AMENDMENT OF SOLICITATION/MODIFICATION OF CONTRACT				1. CONTRACT ID CODE	PAGE 1 OF 3 PAGES
2. AMENDMENT/MODIFICATION NO. AMENDMENT NO. 0009		3. EFFECTIVE DATE 3/8/11	4. REQUISITION/PURCHASE REQ. NO.	5. PROJECT NO. (If applicable) 09-0168	
6. ISSUED BY CODE		jsy	7. ADMINISTERED BY (If other than Item 6) CODE		See Item 6
Officer in Charge of Construction MCI-East 1005 Michael Road Camp Lejeune, NC 28547-2521					
8. NAME AND ADDRESS OF CONTRACTOR (No., street, county, State and ZIP Code)				(X)	9A. AMENDMENT OF SOLICITATION NO. N40085-09-R-0168
				X	9B. DATED (SEE ITEM 11) 2/4/11
					10A. MODIFICATION OF CONTRACT/ORDER NO.
					10B. DATED (SEE ITEM 11)
CODE	FACILITY CODE

09-0168, Building Repairs, AS-4200, MCAS, NR

PIPE RISER

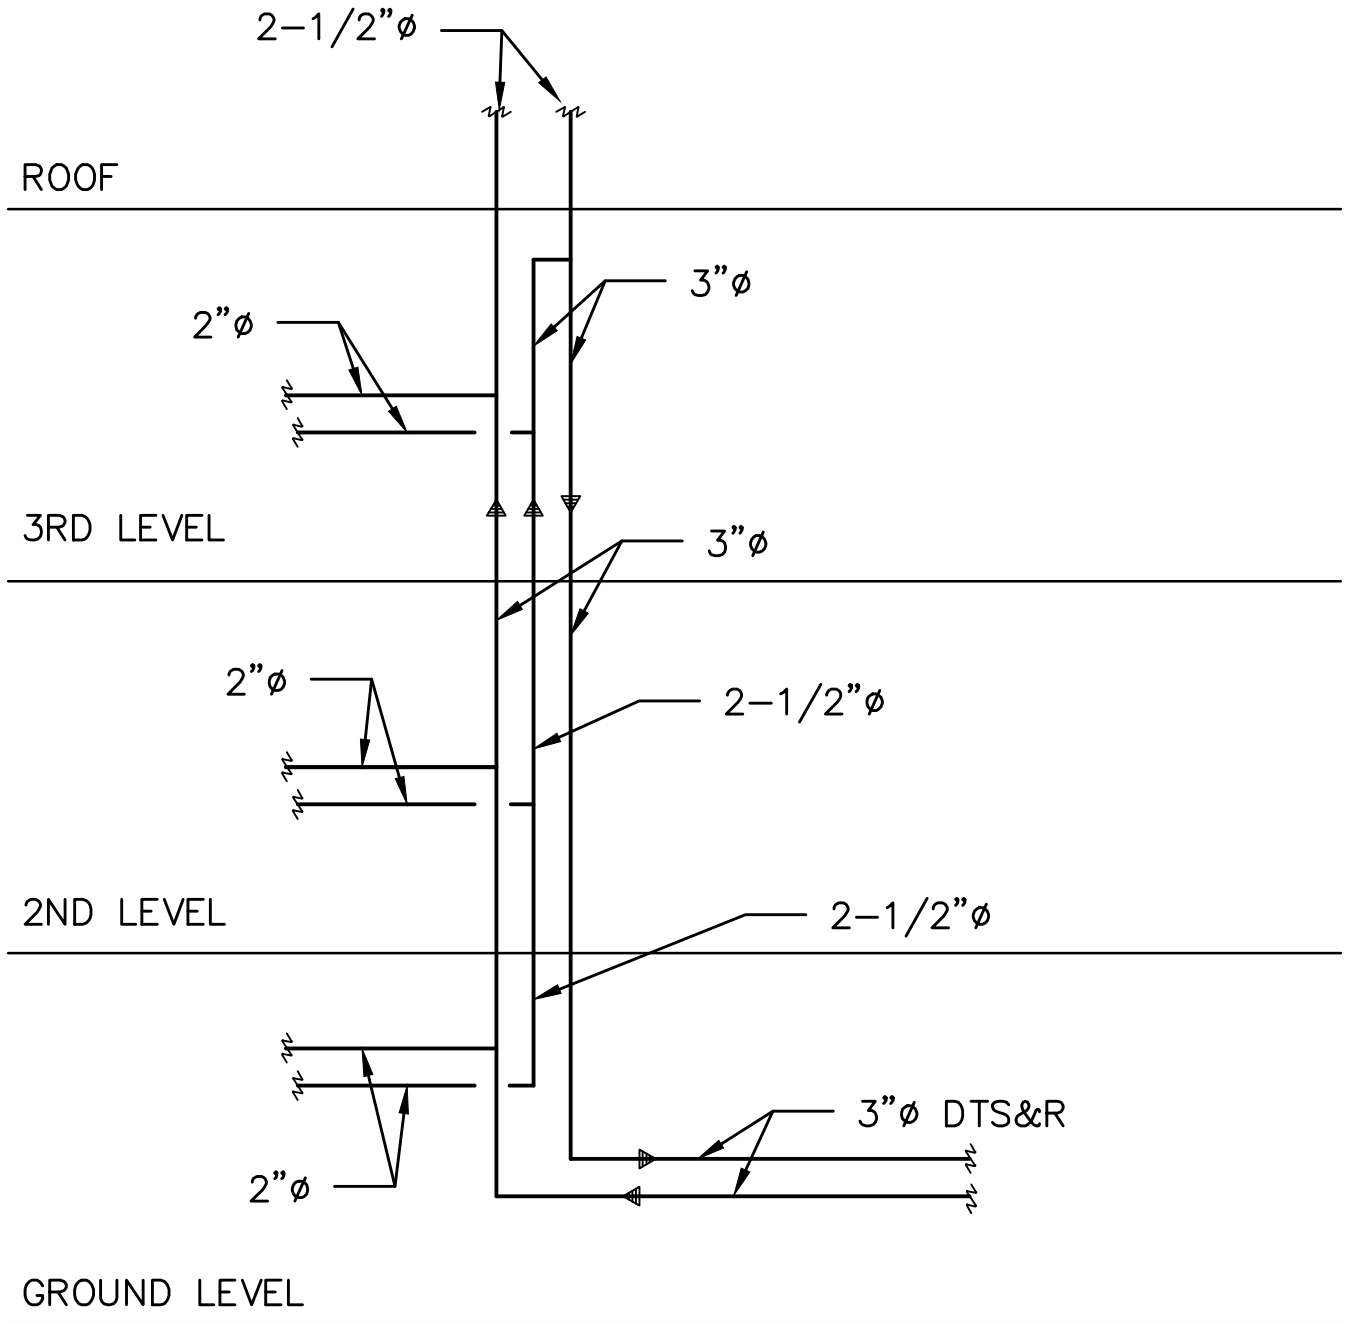
2. QUESTION: Sheet M-5, Detail #1; shows the 3" DTS&R coming into the Mechanical Room and turning upward through the floor. Again this is shown in Detail #10. There is confusion as to how the 2-1/2" pipe (Detail #1) sandwiched between the 3" DTS&R fits into the equation. This 2-1/2" pipe is not shown in Detail #10, and there is no riser drawings reflecting the piping arrangements for such. Please provide clarification and/or a riser drawing showing the routing of the 2-1/2" pipe.

2. ANSWER: The dual temperature system is piped in a reverse return configuration. See the attached piping riser diagram for further detail.
